Technical Bulletin 005 – 05/12/2025

Evok- New software release 1.8.0

Software release details – 1.8.0

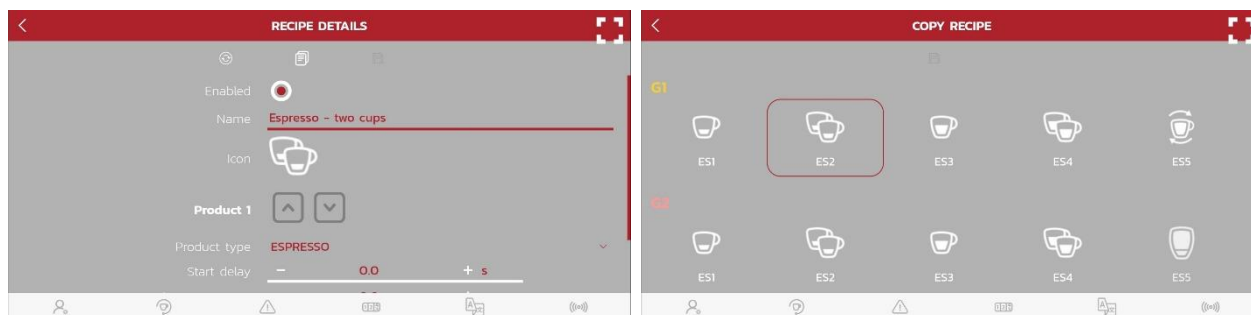
- **REMOTE CONNECTION: INTRODUCTION OF FTP PROCEDURE** – Remote software upgrade is now available (see the [remote configuration](#) procedure)
